SUBMISSION TO THE NT ENVIRONMENT PROTECTION AUTHORITY

RE: PROPOSED DEVELOPMENT ON LOT 7651 (LITTLE MINDIL) TOWN OF DARWIN

This submission is in response to a proposal for construction of apartments, hotel and associated structures on Lot 7651 (Little Mindil) Town of Darwin by KTT Investments Pty Ltd (the proponent). Specifically, this submission responds to some issues addressed in an EPA Referral Report prepared by BPL Environmental (the Report).

1 OVERALL PLAN - SEMI-BASEMENT DT
1:500

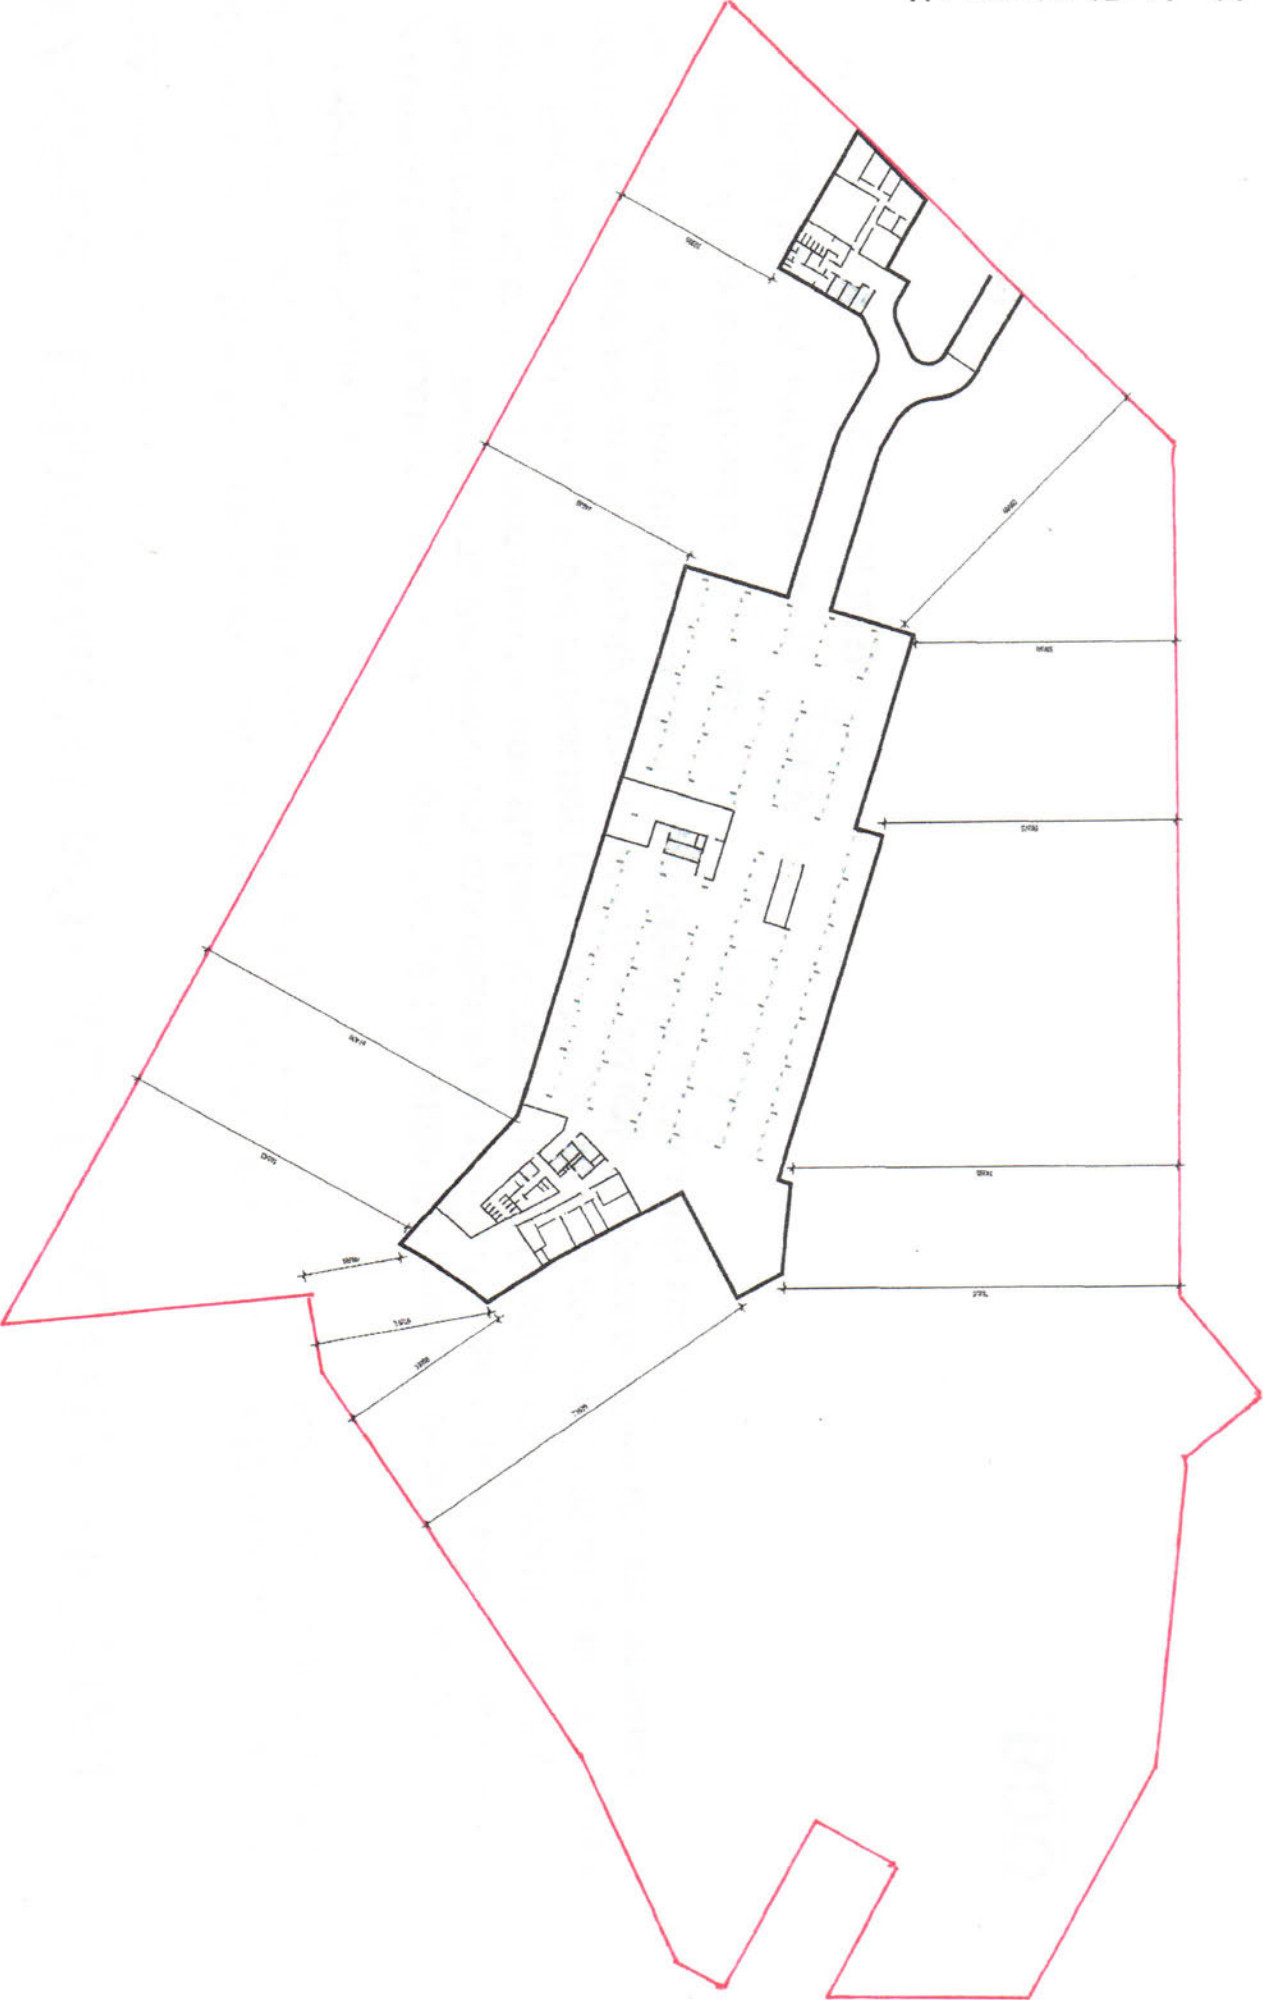
More than 15% of the site will need to be excavated for the semi-underground carpark, which will have a finished internal area of 7,608m² (See Attachment A). The depth of the excavation will need to be about 2.6 metres below the existing ground level (See Attachment B). Excavations below the existing natural ground level will also be required for the sixteen lagoon villa swimming pools and partial excavation for the three garden villa swimming pools. The plan to bury the high tension power cable will probably also require intrusion into the existing soil profile.

ATTACHMENT A

The above drawing is based on Hachem Architects drawing TP3.01 and TP3.03

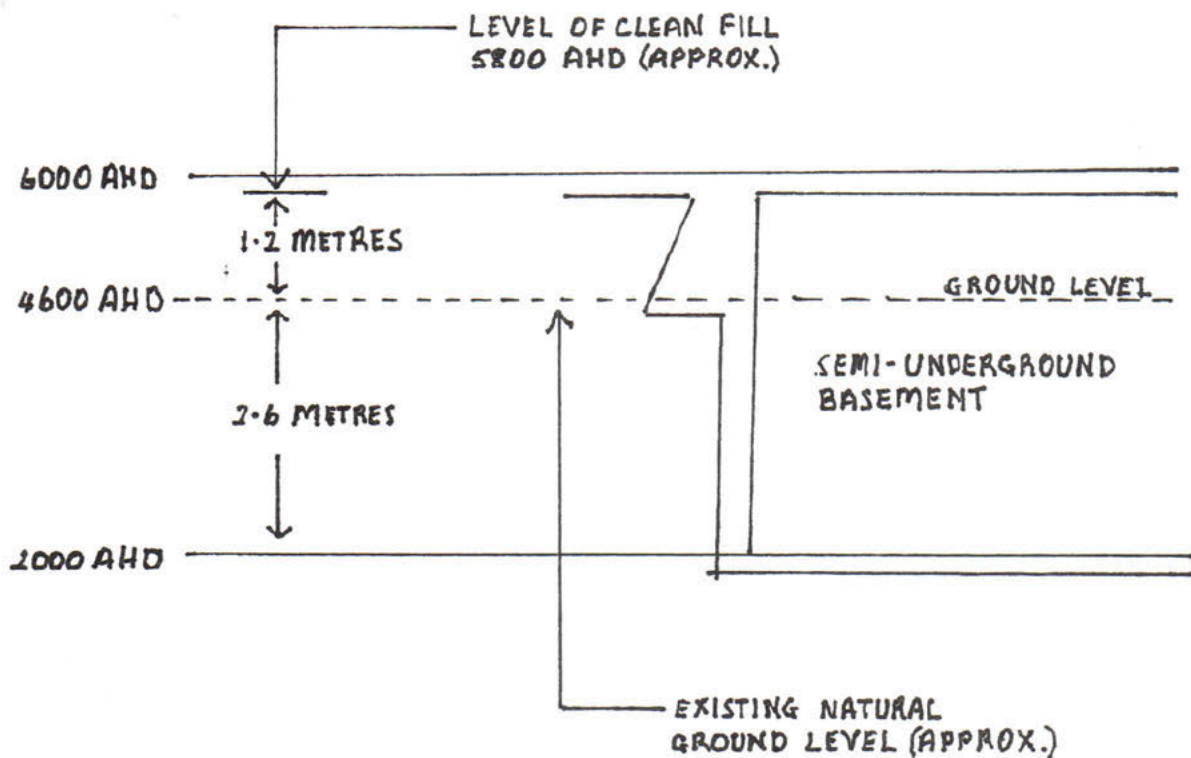
These suggest the existing natural ground level at the beachside footpath is approximately at 4600 AHD (Australian Height Datum). Clean fill is to be brought in to raise that height to about 5800 AHD.

Therefore, the semi-basement carpark with a finished floor surface at the 2000 AHD level will require an excavation of at least 2.6 metres (4600 AHD – 2000 AHD) depending on natural ground level variability and up to 3 metres to allow for underfloor work, e.g., sump pits etc.
